802.1AB/D12 Sponsor Confirmation Ballot Comment Summary

Paul Congdon
11/18/2004
San Antonio, TX

Figure 9-12—Basic format for Organizational Specific TLVs

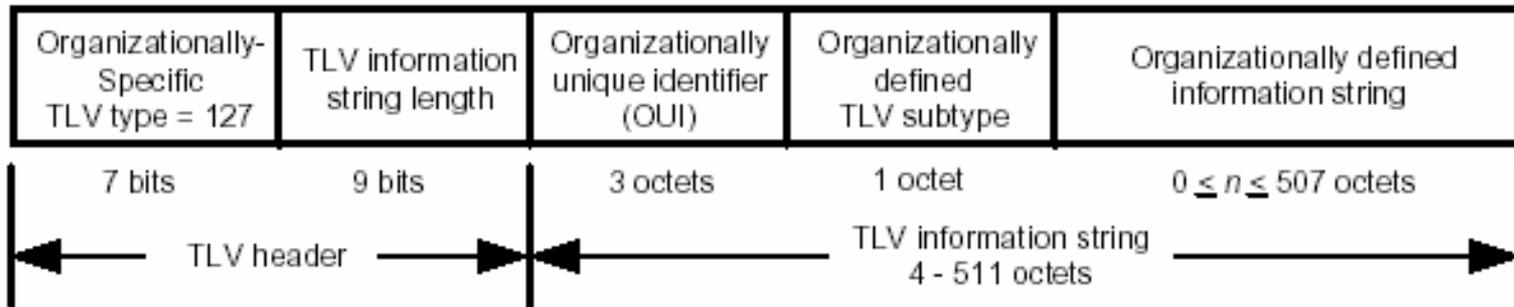
Field names [should] be spelled the same, whether in a figure or in text. What is less clear is whether you want to adopt the same convention within subclause headings, where its more consistent but looks a bit funny.

Don't capitalize field names in figures, unless that is how they are normally spelled in the middle of a sentence. Changes apply here and everywhere.

9.6.1.3 Organizationally Unique Identifier (OUI)

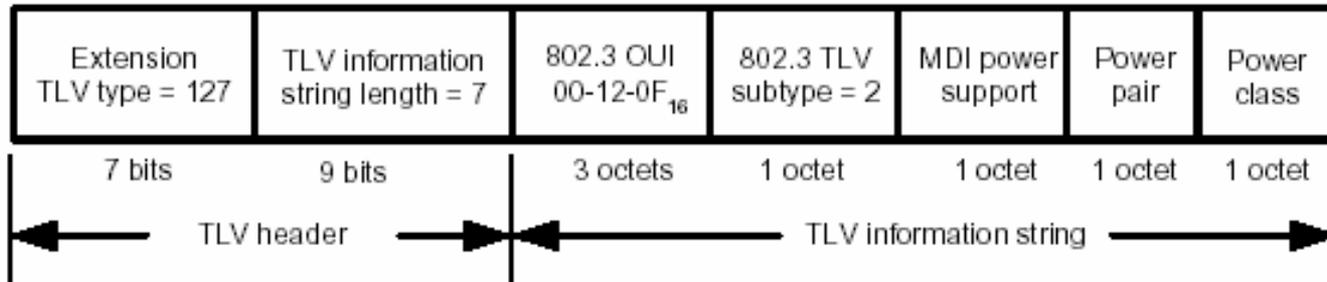
The mapping of the OUI must be accurately defined, in terms of the IEEE/RAC supplied values, expressed in the format-assignment letter. The current reference is bit-oriented (not hex oriented, vertically oriented (not horizontal oriented), puts LSB on the left (not right), described different things (40-bit and 48-bit), which makes the reference difficult to understand in this context.

The Organizationally Unique Identifier field shall contain the organization's OUI. For example, when using the 802.1 OUI value of 00-80-C2, 00 and C2 bytes correspond to the first and last of these three transmitted bytes, respectively (see F.2).
